Department of Fish and Wildlife

April 20, 2010

Subject: Yellowstone Trail Estates (LP-09-00006) Plat revision and amended Critical Areas Report – Comments related to revisions.

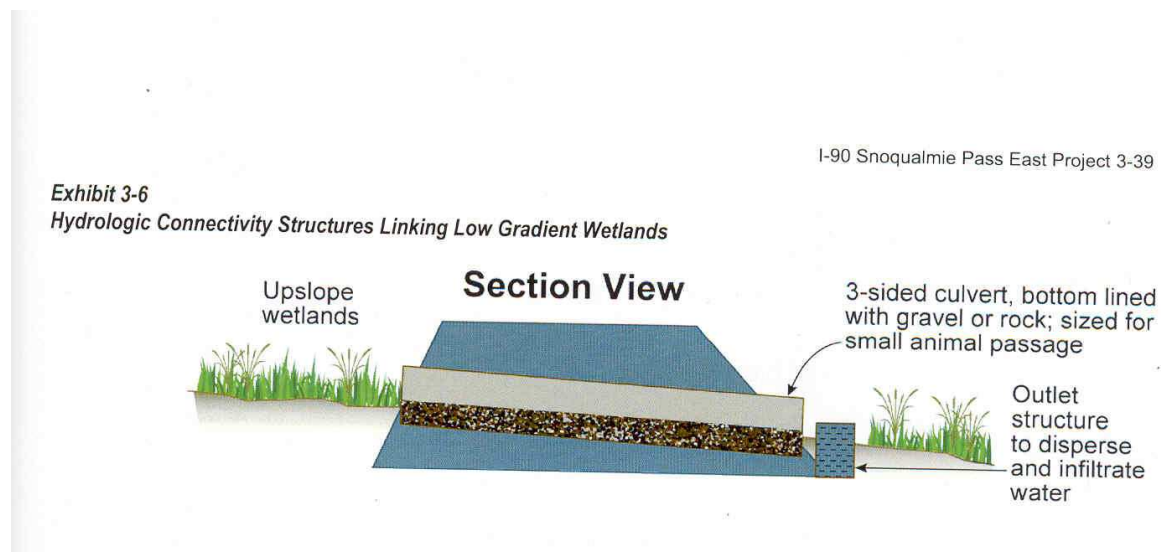
- d. **Crossing structure for Wetland C.** As noted in the Critical Areas Report Addendum, the road crossing of Wetland C should be designed to provide passage for

amphibians and small mammals as well as water. I have enclosed some conceptual design information for discussion. The crossing will need to have sufficient hydraulic capacity to pass expected snowmelt runoff and stormwater, a natural substrate, and some additional width to allow for some “shoreline edge” along the margins of the crossing. The crossing structure should be a box culvert or pipe-arch, with a span of not less than 42-inches and a rise of not less than 29-inches (this is hydraulically equivalent to a 36-inch round pipe). WDFW can provide more specific guidance once the site is staked and accessible for field inspection.

Figure 1. Conceptual wetland crossing structure taken from I-90 Snoqualmie Pass East Project. The depicted outlet structure would not likely be needed at Wetland C because of the low gradient. Substrate in the culvert would include some large cobbles and small boulders to provide channel roughness and protective cover for amphibians and small mammals. If predicted water volumes and velocities allow, some woody debris could be included along one of the culvert walls.

2. The road crossing design for Wetland C shall be submitted for review and approval by KCCDS in consultation with WDFW. The crossing shall be a box culvert or pipe-arch, with not less than 42-inch span by 29-inch rise, sized to convey snowmelt runoff and stormwater and accommodate passage of small mammals and amphibians.

The crossing structure should be a box culvert or pipe-arch, with a span of not less than 42-inches and a rise of not less than 29-inches (this is hydraulically equivalent to a 36-inch round pipe). The structure should be designed to have sufficient hydraulic capacity to pass expected snowmelt and stormwater runoff, with enough additional capacity/width to allow for some "shoreline edge" to be created along the margins of the culvert walls.
